SUBJECT: Provides response to NRC request for addl info re low upper shelf toughness fracture analysis of reactor vessels for load level A & B Conditions.

Re: Turkey Point Units 3 and 4
Docket Nos. 50-250 and 50-251
TAC Nos. M68249 and M55042
Low Upper-Shelf Toughness Fracture Analysis
of Reactor Vessels for Load Level A & B Conditions
Response to Request for Additional Information

REQUEST FOR ADDITIONAL INFORMATION (RAI)
REGARDING

Figure 4-22 J-R Model and Unirradiated HSST Data Comparison

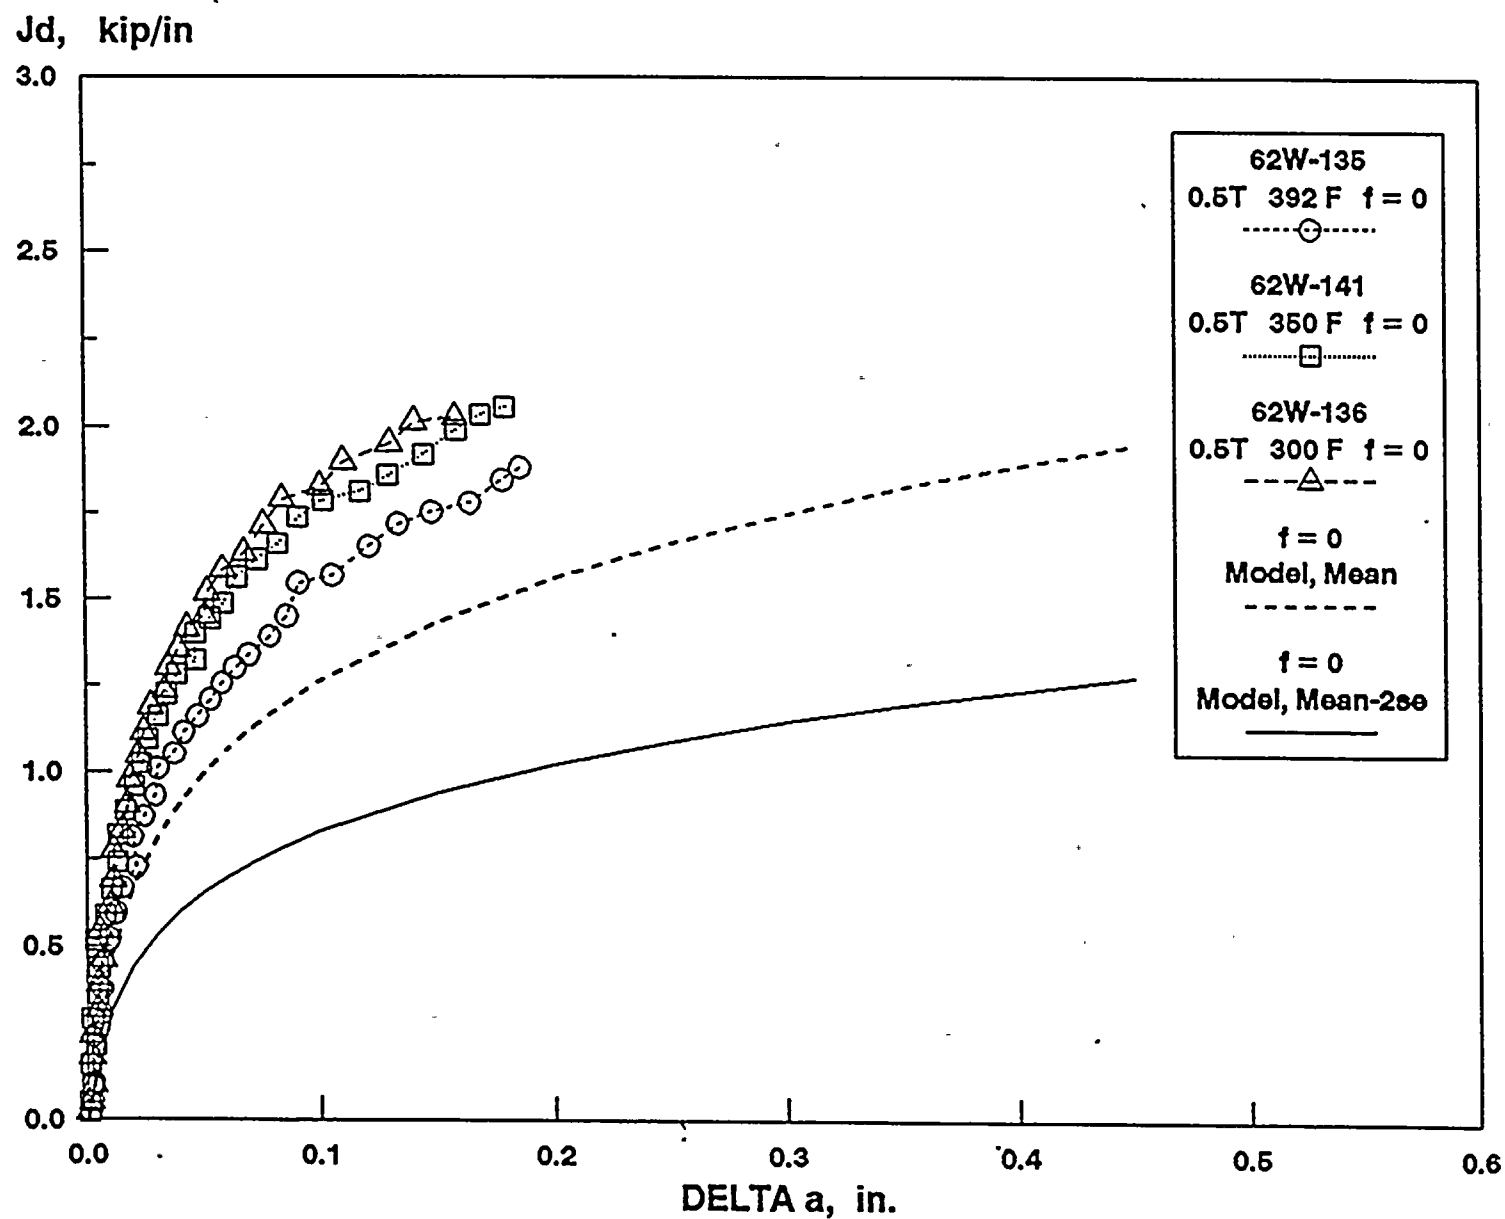
3. Explain the relationship between the irradiated HSST and the J-R model curves in Figures 4-22 and 4-23.

Attached clearer figures are to replace Figures 4-22 and 4-23. Since J_H is not used in this analysis, J_H - Δa curves are deleted. The text on pages 4-10 and 4-11 is modified as follows:

In Figure 4-22, three selected unirradiated SA-1101 J-R curves and the 4T CT irradiated specimen data J-R curves are shown with a mean and a lower bounding J-R curves predicted by the model equation for unirradiated material ($f = 0$). It is obvious that SA-1101 is relatively tougher material in Mn-Mo-Ni/Linde 80 weld metal. The predicted mean curve for unirradiated material is much lower than the irradiated material curve. There is only one irradiated CT specimen of SA-1101 available from the HSST data set, i.e. 62W-25, a 4T CT specimen with fluence of 1.4×10^{19} n/cm², tested at 350 F. This material J-R curve was compared with the model predicted curves as shown in Figure 4-23. It is apparent that this model is very conservative for this application. There exists a factor greater than 3 on J values between the test data and the lower bounding model curve. The same J-R data points are plotted against model curves with the same fluence as the 4T CT specimen in Figure 4-23.
